AMENDMENT OF SOLICITATION/MODIFICATION OF CONTRACT			1. CONTRACT ID CODE	PAGE OF PAGES
2. AMENDMENT/MODIFICATION NO. 0001	3. EFFECTIVE DATE 14-Jun-2023	4. REQUISITION/PURCHASE REQ. NO.		5. PROJECT NO.(If applicable)

14. DESCRIPTION OF AMENDMENT/MODIFICATION (Organized by UCF section headings, including solicitation/contract subject matter where feasible.) The above numbered Solicitation for West Shore Lake Pontchartrain, Louisiana, Hurricane and Storm Damage Risk Reduction Project, Levees and I-10 West T-Wall Crossing, WSLP-106, St John the Baptist Parish, Louisiana has been amended to: a) Provide updated plans and specifications. b) Provide updated bid schedule. c) Provide answers to prior questions d) All questions are due NLT 11:00am CST on June 22, 2023 e) Bid submission date changed to June 29, 2023, at 10:30am CST				
Except as provided herein, all terms and conditions of the document referenced in Item 9A or 10A, as heretofore changed, remains unchanged and in full force and effect.				
15A. NAME AND TITLE OF SIGNER (Type or print)		16A. NAME AND TITLE OF CONTRACTING OFFICER (Type or print)		
		TEL:	EMAIL:

WSLP-106 PRE-BID QUESTIONS

SHEET IDENTIFICATION
 C-302

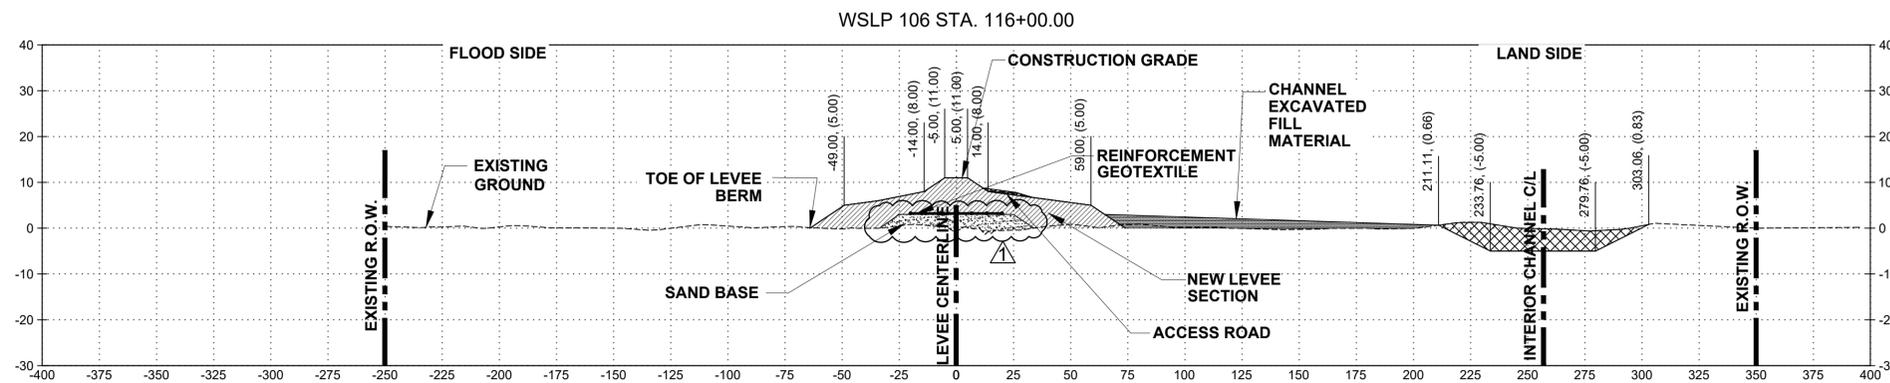
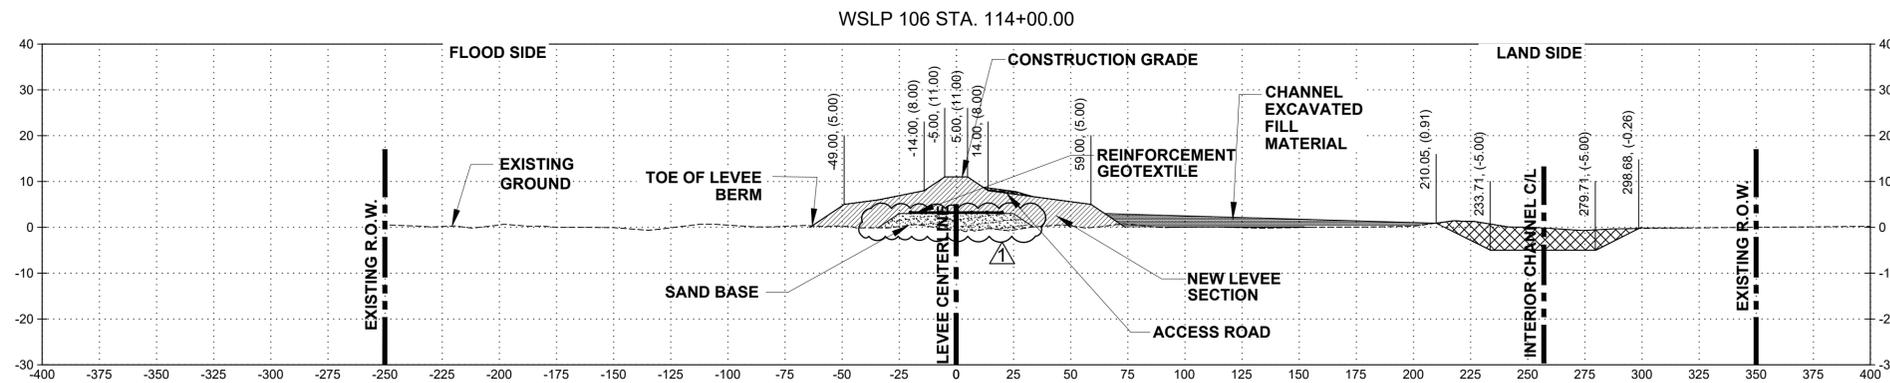
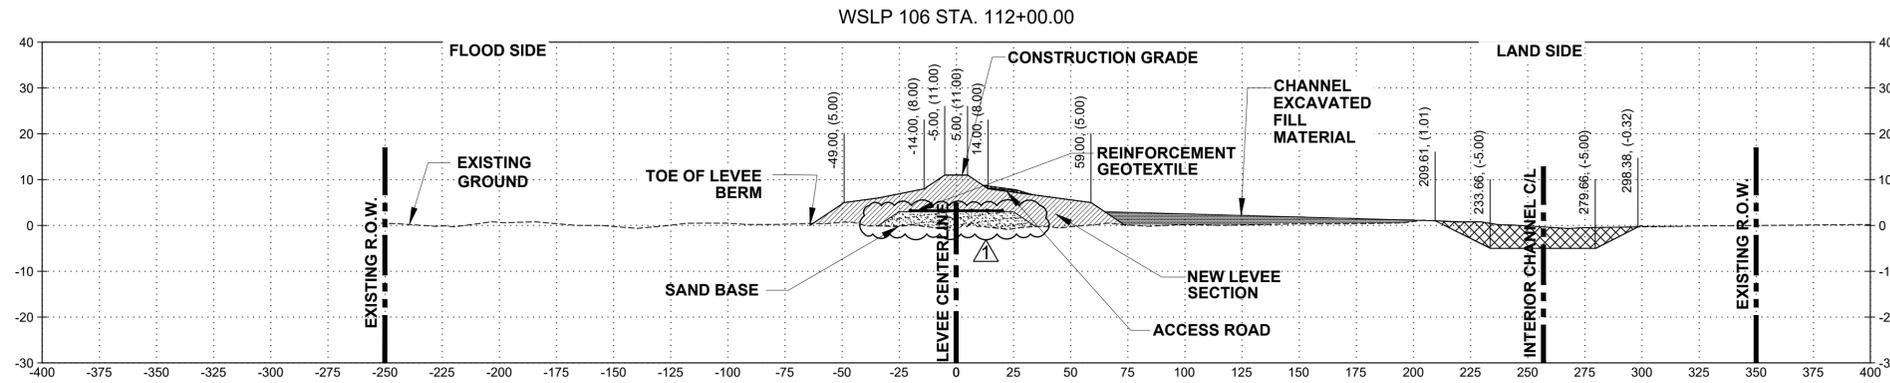
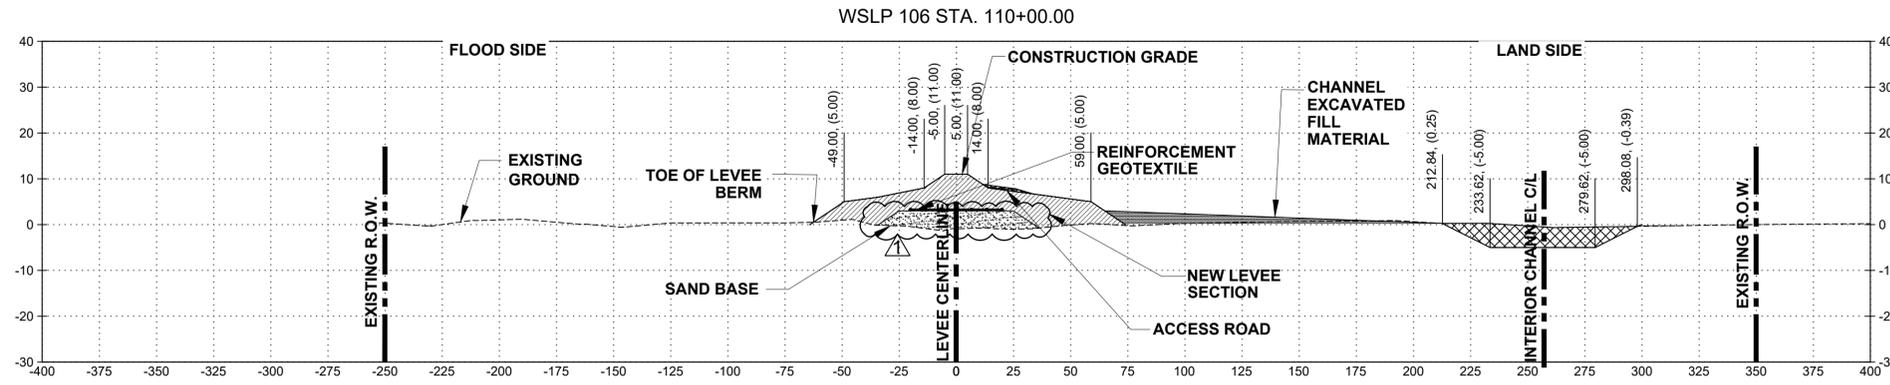
25. The cross sections on drawings C-301 thru C-306 depict the sand base and levee embankment being placed below the existing ground line. Is the Government's intent to excavate to these template lines and grades prior to placing the sand base and levee embankment? **No. Cross Sections shall be revised by Amendment. This is addressed by Amendment 0001.**

DATE	DESCRIPTION	APPR.	MARK
6/6/2023	REVISE SAND BELOW EXISTING GRADE	K.K.	Δ

SHEET IDENTIFICATION
C-305

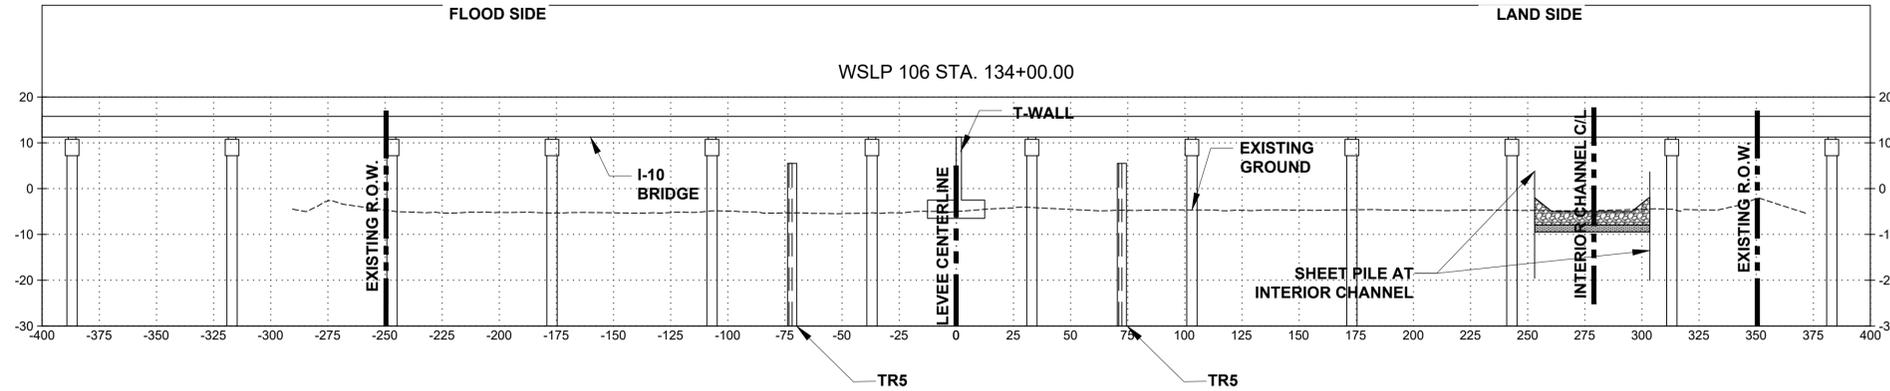
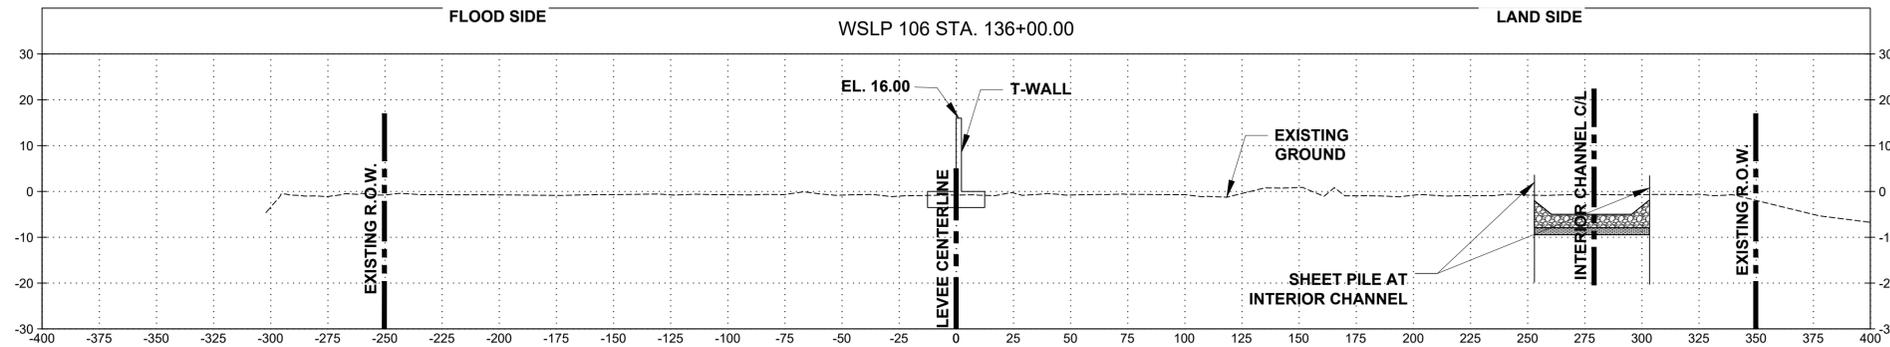
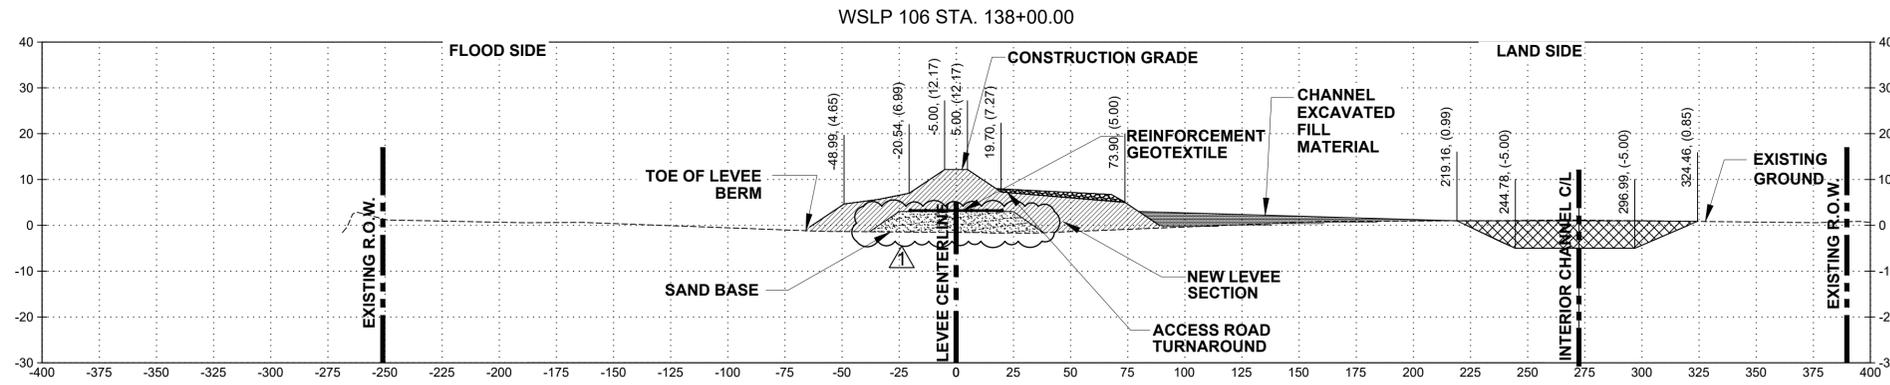
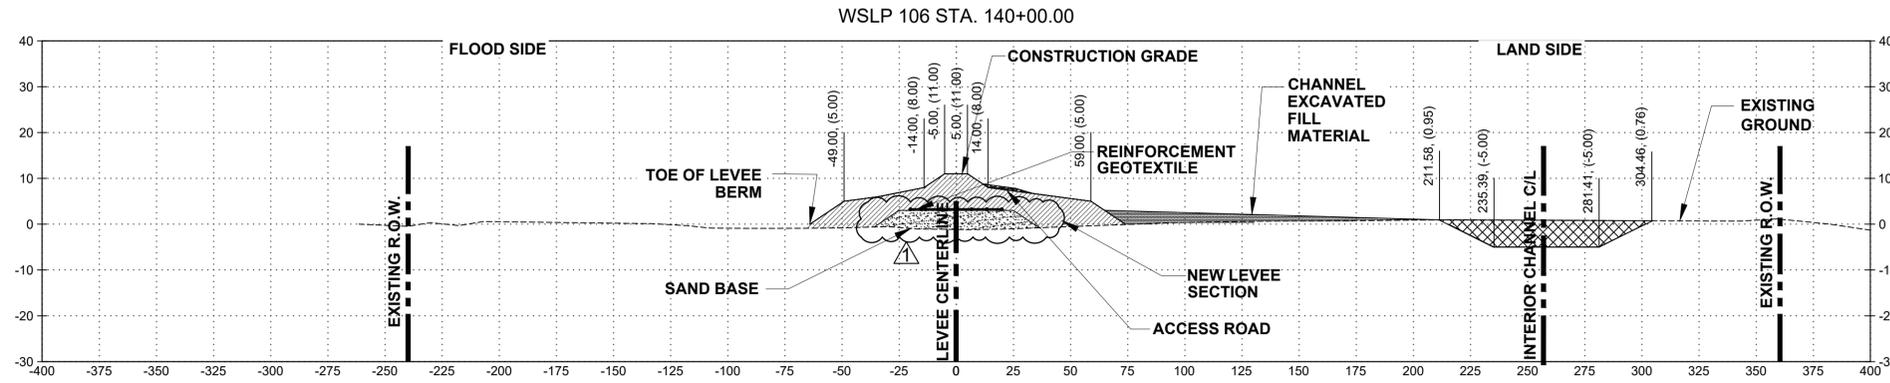
DATE	DESCRIPTION	APPR.
6/6/2023	REVISE SAND BELOW EXISTING GRADE	K.K.

SHEET IDENTIFICATION
C-306

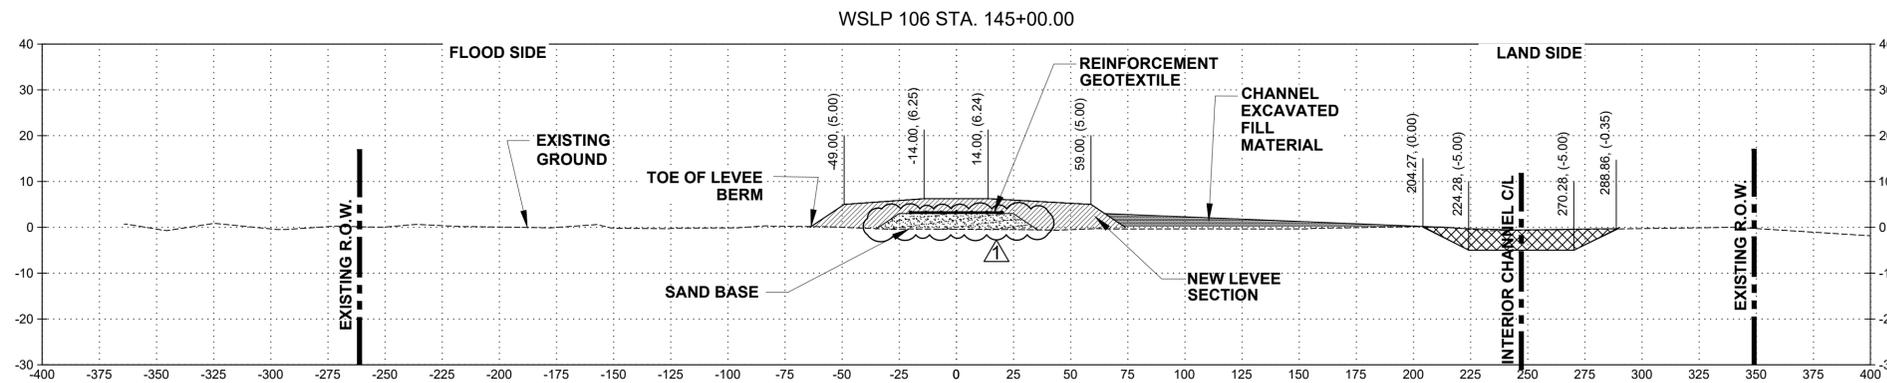
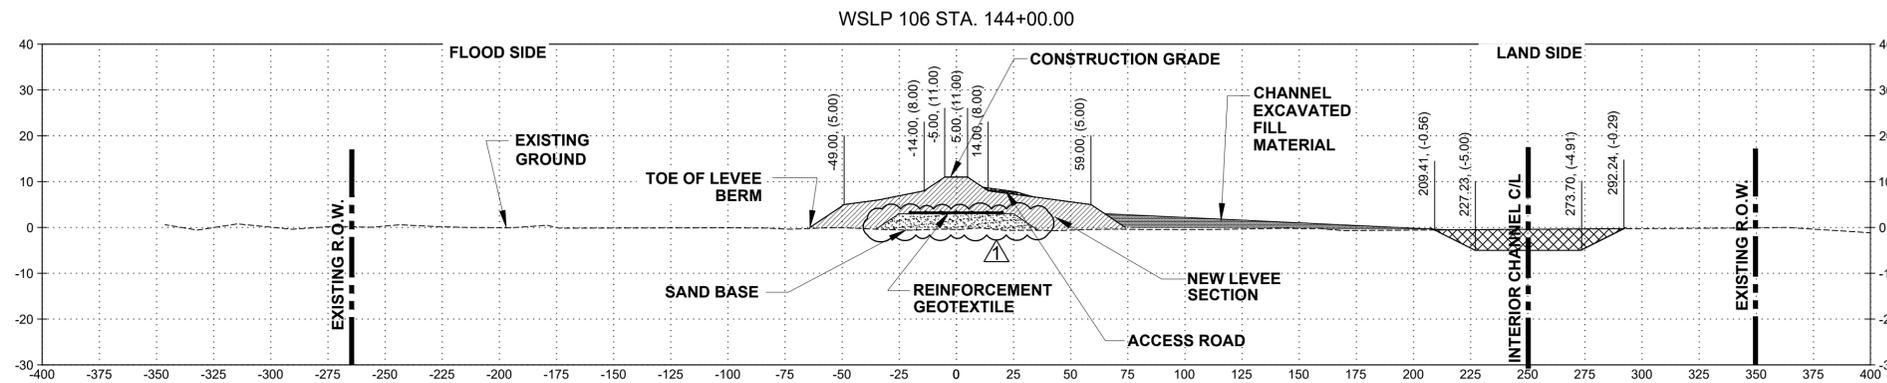
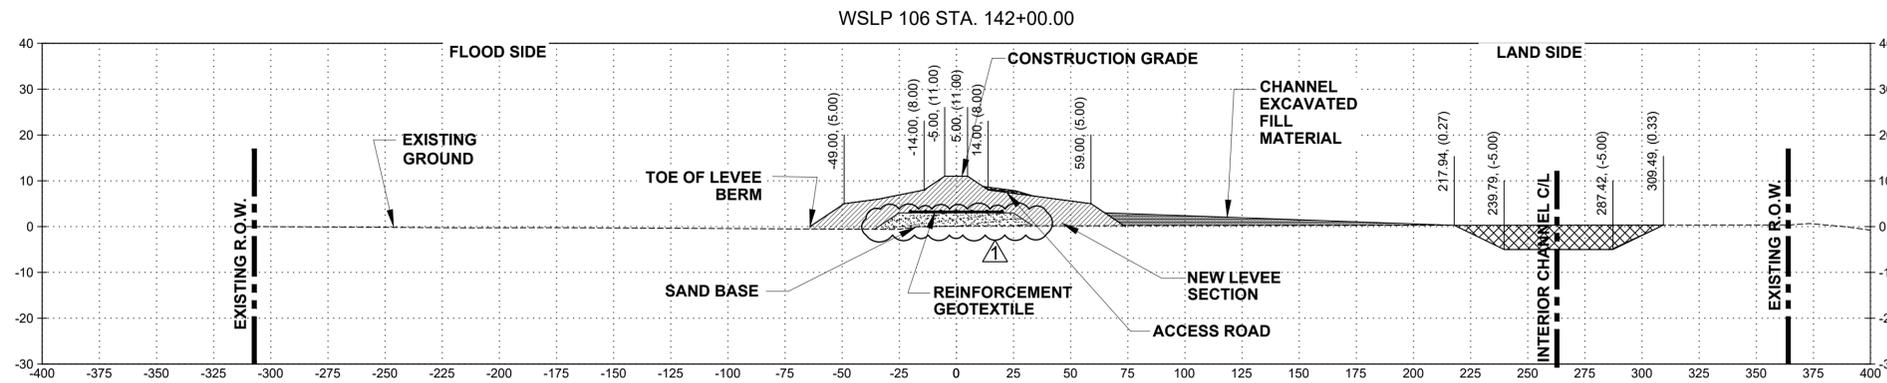
MARK	DESCRIPTION	DATE	APPR.
Δ	REVISE SAND BELOW EXISTING GRADE	6/6/2023	K.K.
